July 6, 1987

Frank Jensen, Soils Reclamation Specialist Frank Jaw Sex

ACT/043/004 - Utelite Corporation

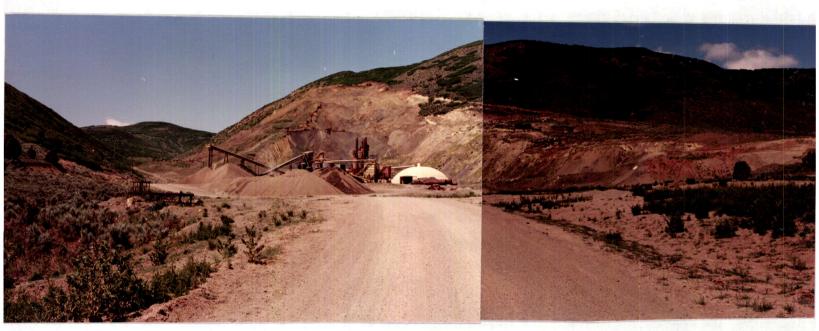
Photo showing the very good soil material for reclamation. Also note the Canada thistles in the foreground. They are capable of completly taking over all of the disturbed area of the mine.

The Canada thistles should be sprayed. Spraying with 2,4-D and Banvel or Tordon at label recommendations will kill most of them - but it will take repeated treatments.
